ADDENDUM NO. 2
TO THE
DRAWINGS AND SPECIFICATIONS
FOR THE
17TH Street Reconstruction

Issued From: The City of Bloomington
Planning and Transportation Department
Post Office Box 100
401 North Morton Street, Suite #130
Bloomington, Indiana 47402

Issue Date: January 29th, 2019

CITY OF BLOOMINGTON	
RAILING DETAILS

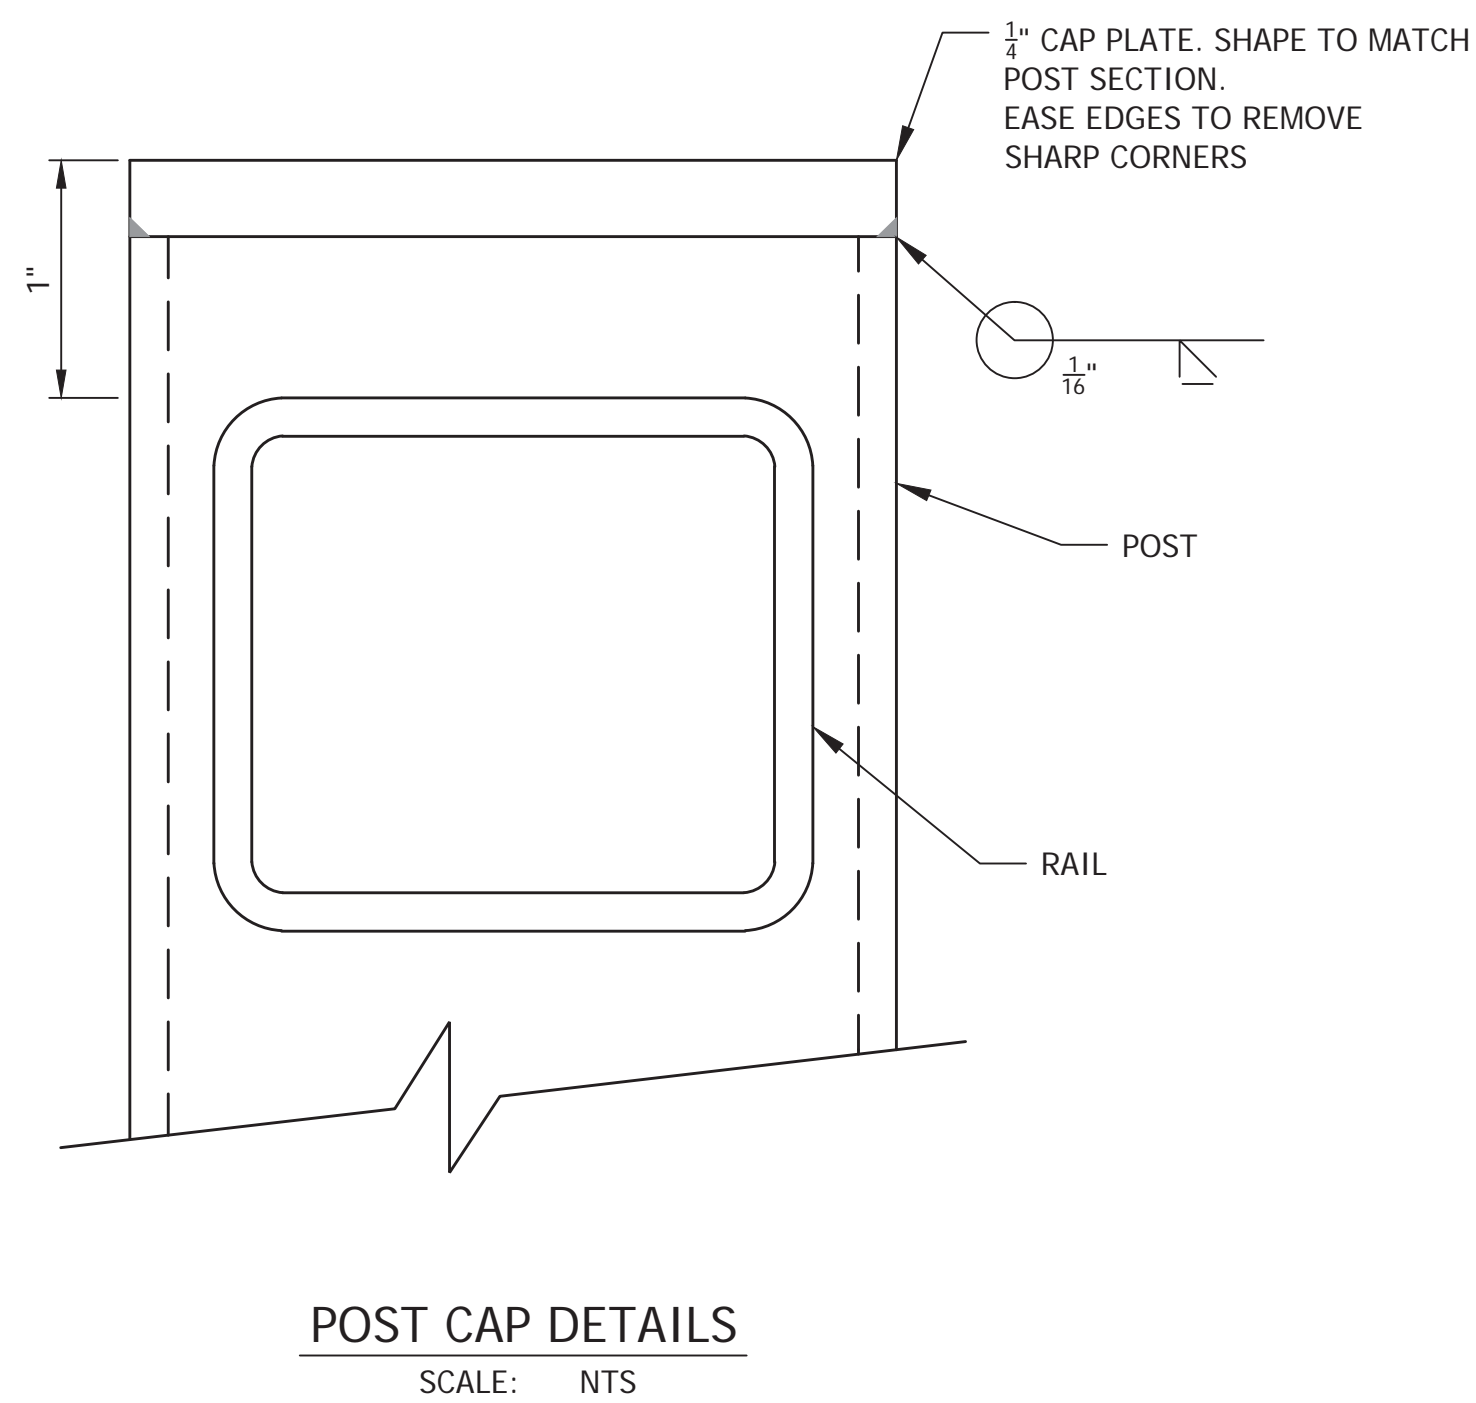
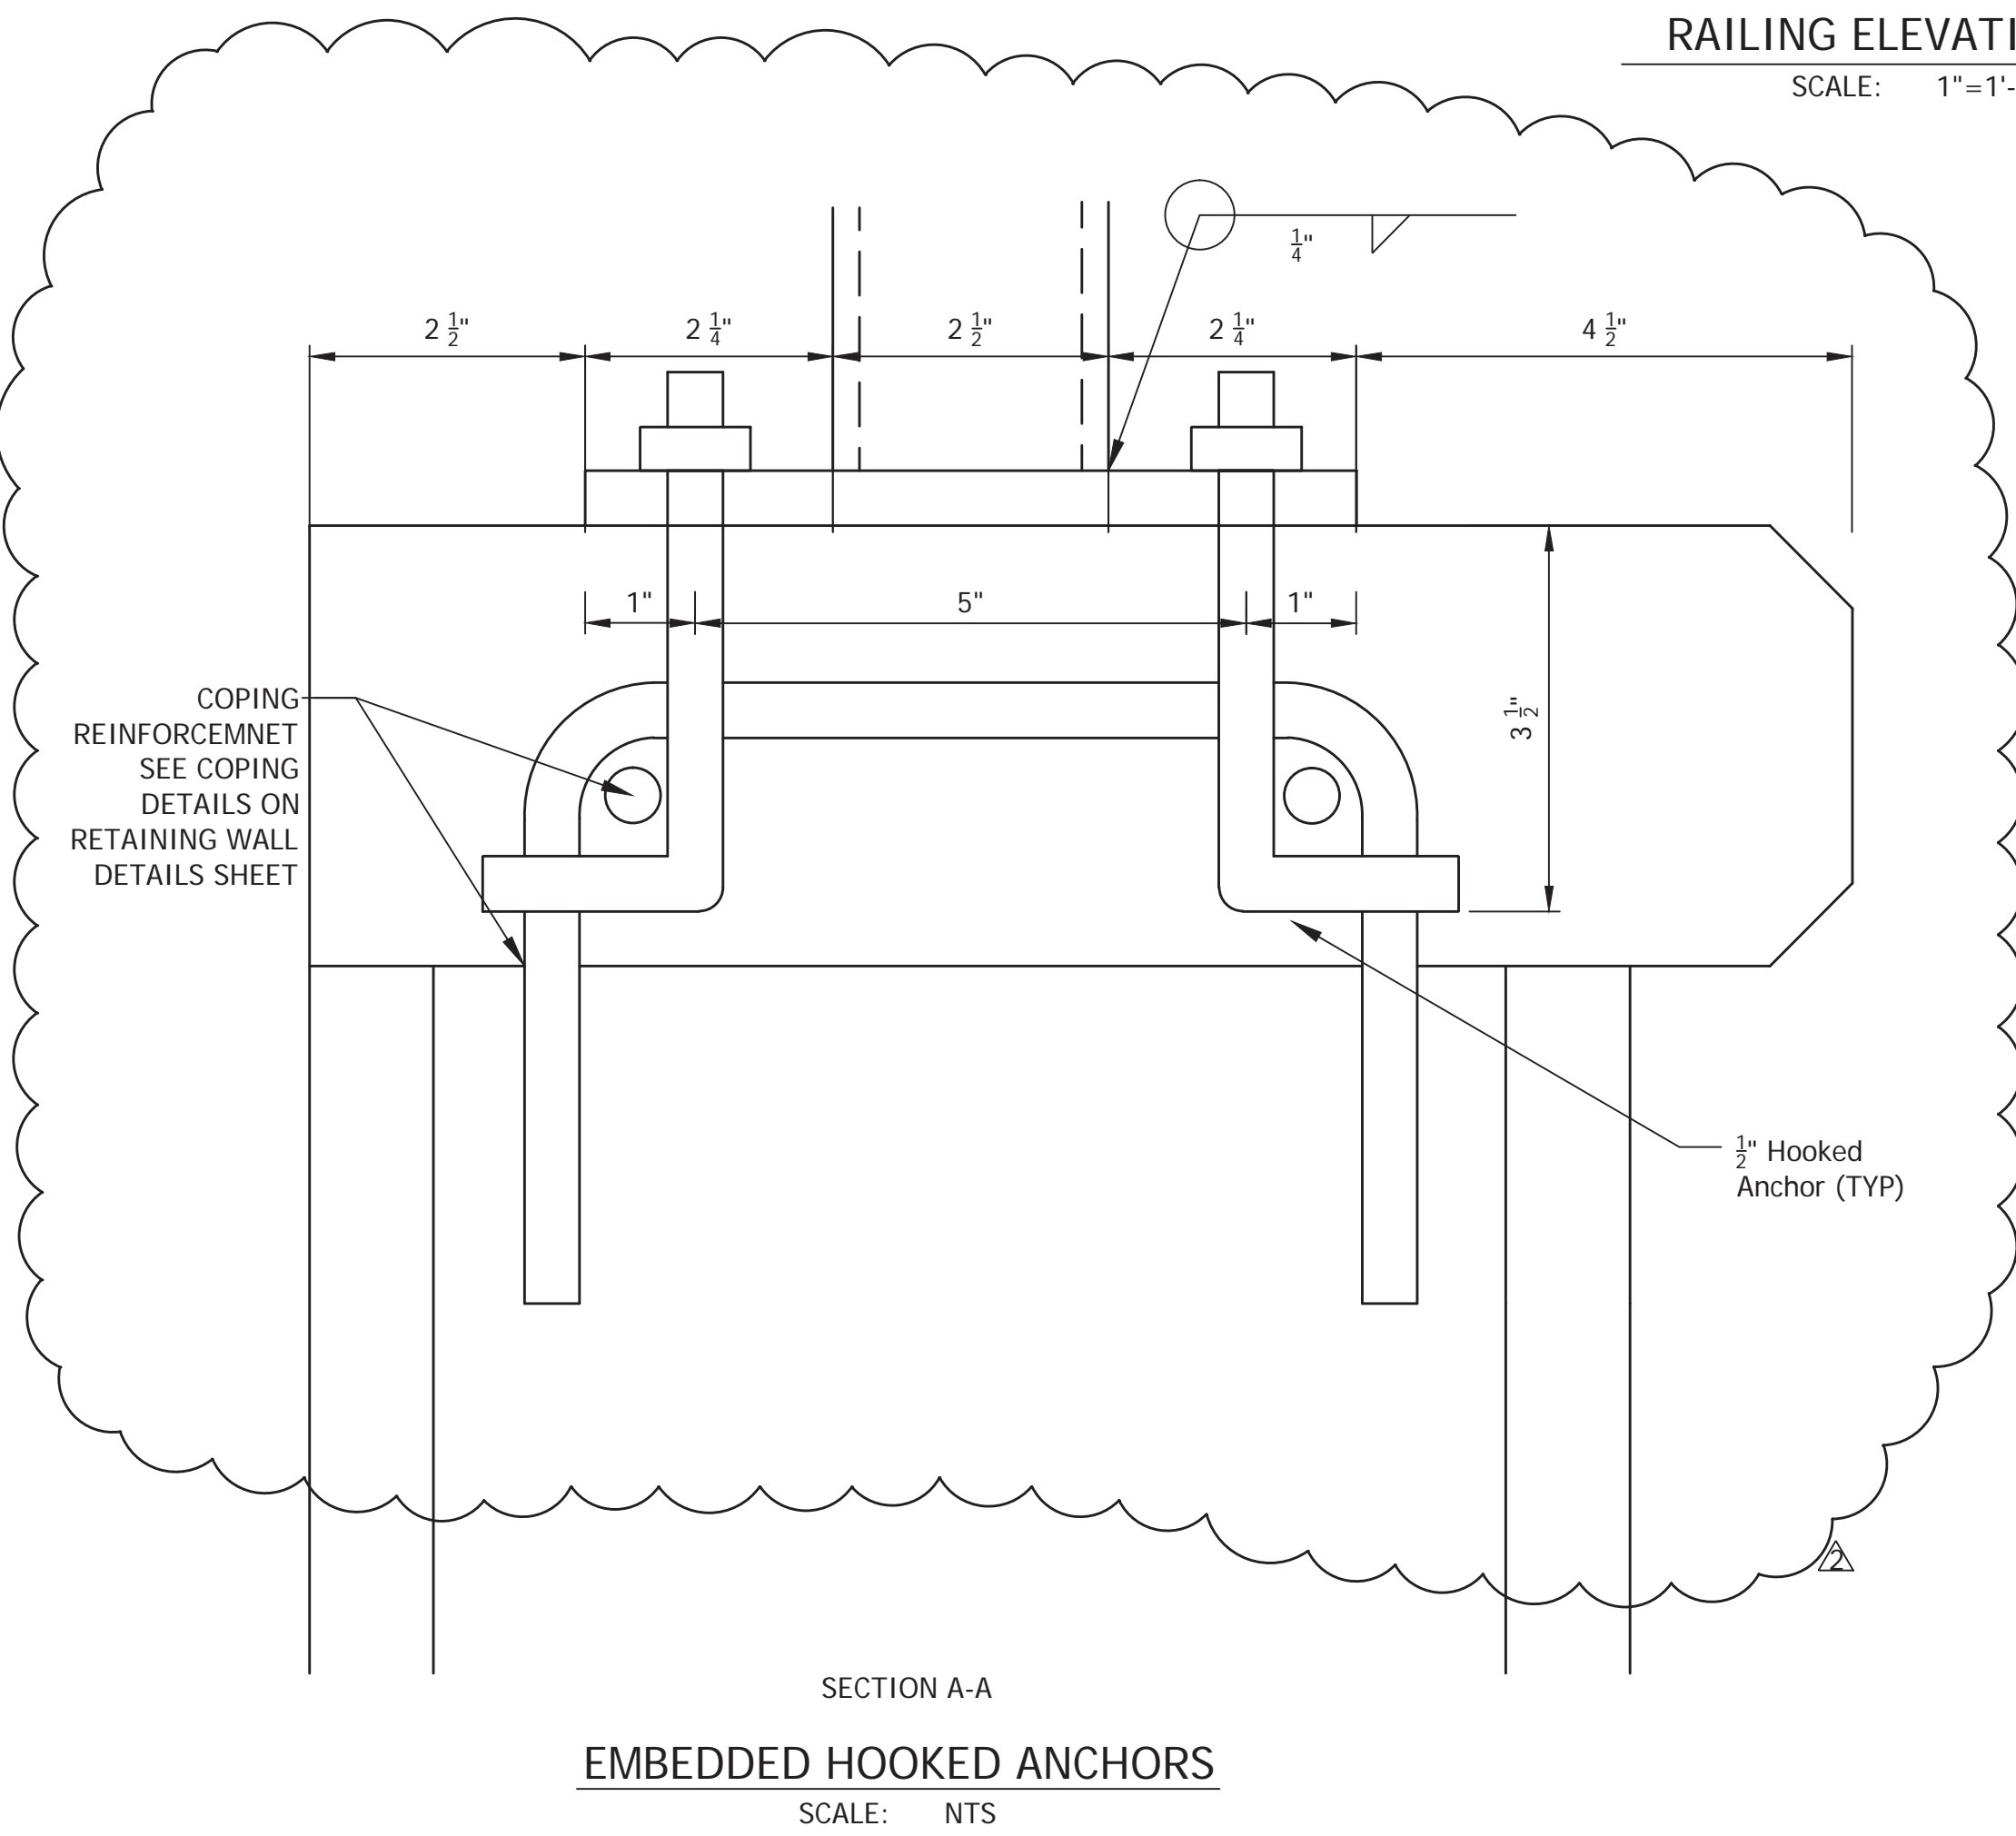
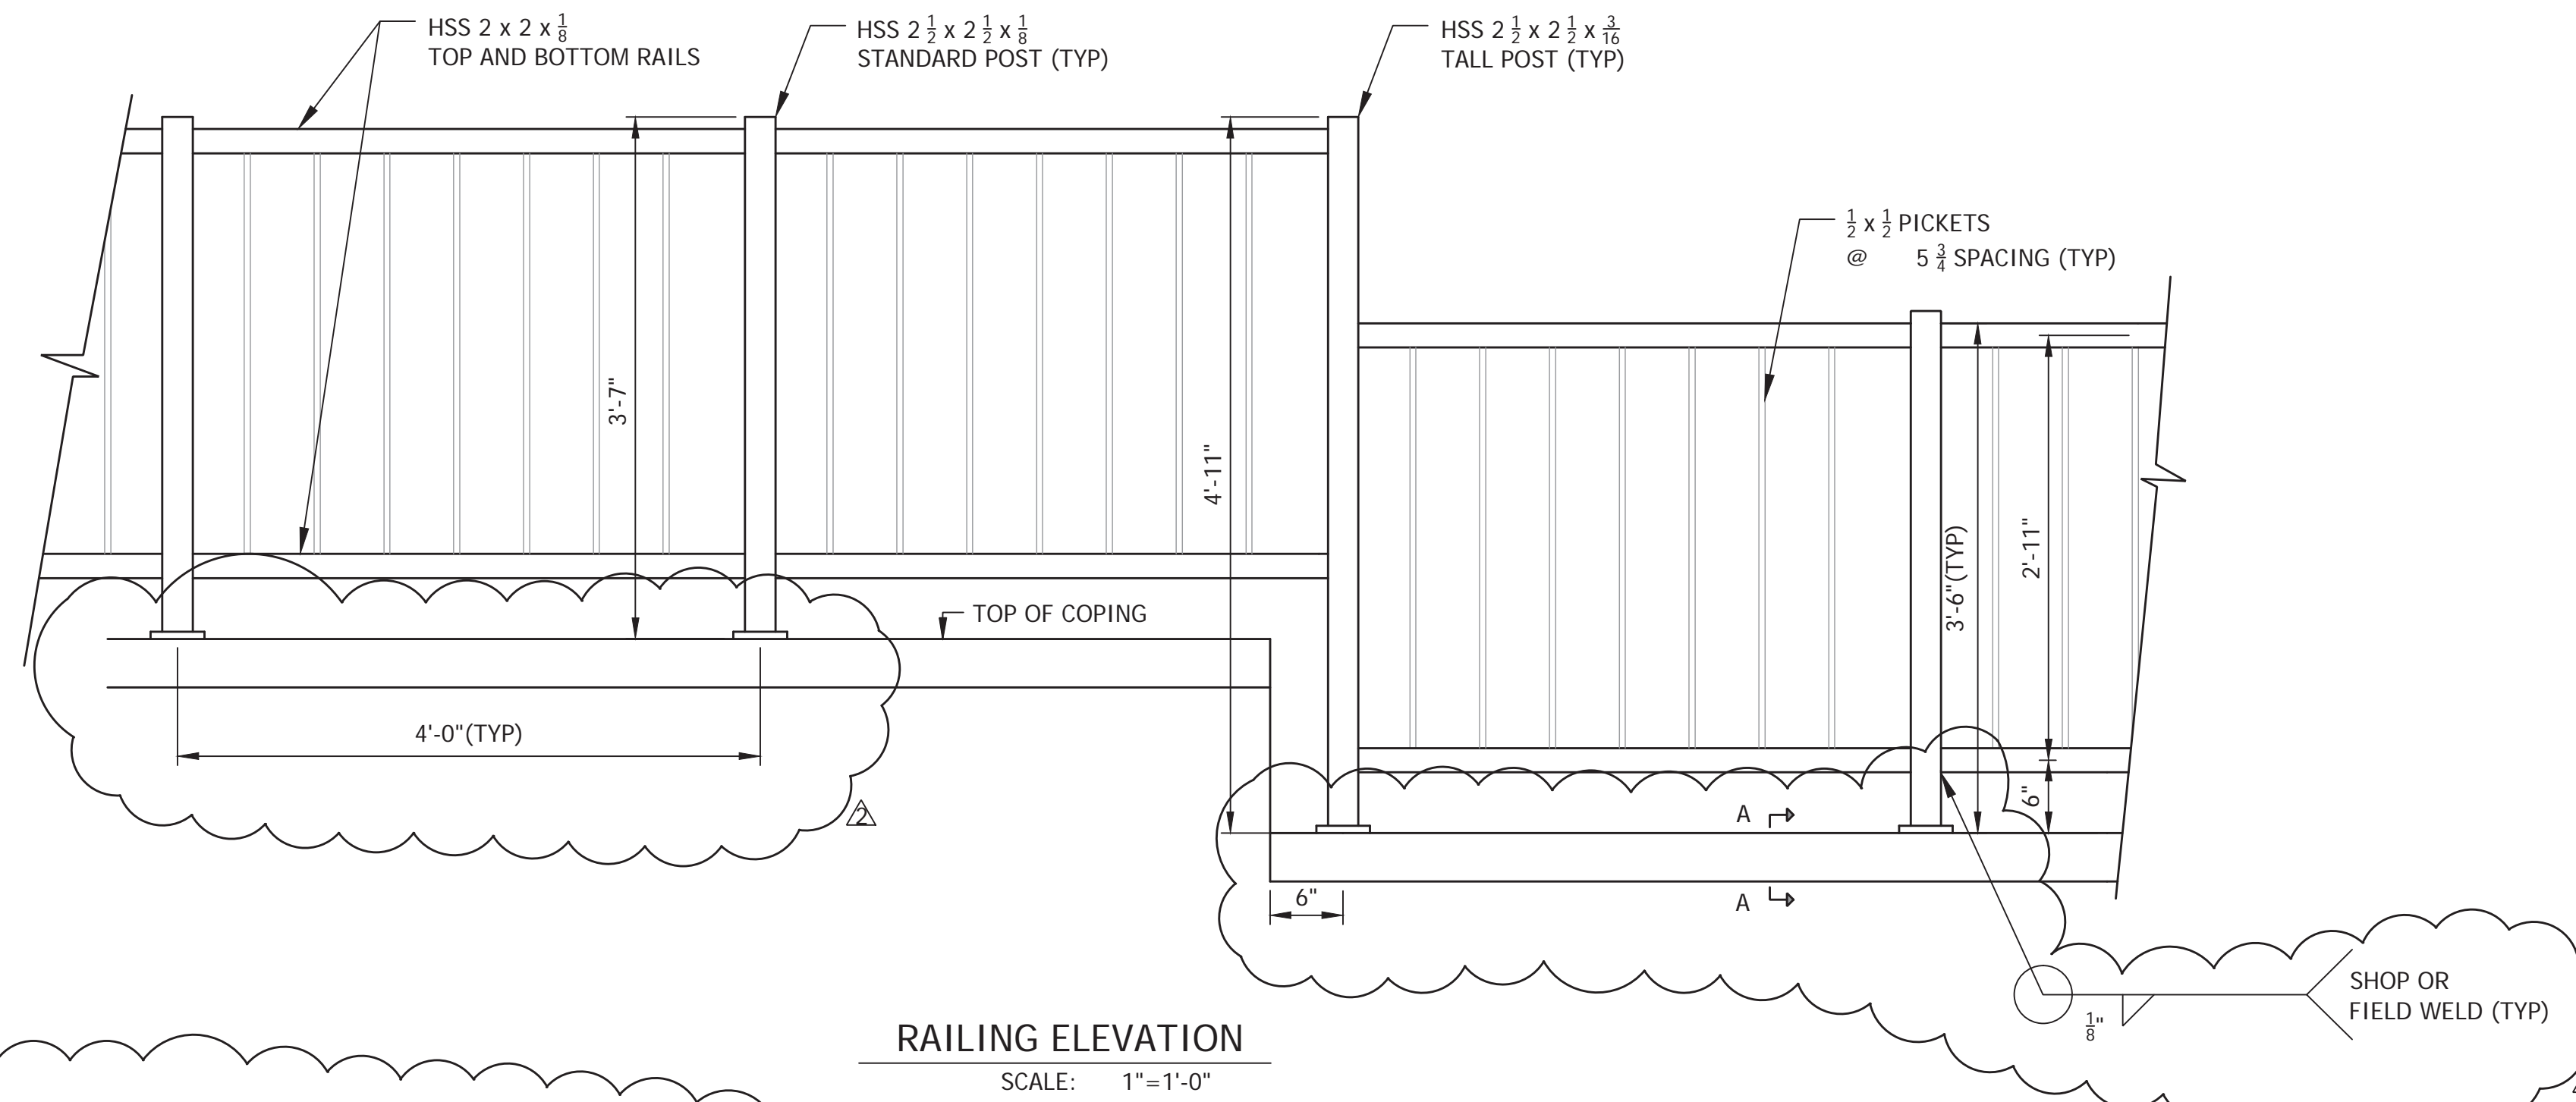
The item "Coping, Cast-In-Place" to be paid per lineal foot has been added to the contract. The work shall be in accordance with the details as shown on the plans. The Railing Detail on sheet 65 of the plans has been revised to eliminate the embedding of the base plate and to include embedded hooked anchors, in order to eliminate the need for field welding. The cost of the embedded hooked anchors shall not be paid for separately but shall be included in the per lineal foot cost of "Coping, Cast-In-Place". A revised plan sheet and the updated "Proposal Schedule of Items" have been added per this addendum.

The railing material shall be as called out on the plans. The Railing Detail on sheet 65 of the plans has been revised to eliminate the embedding of the base plate and to include embedded hooked anchors into the cast in place coping, in order to eliminate the need for field welding.
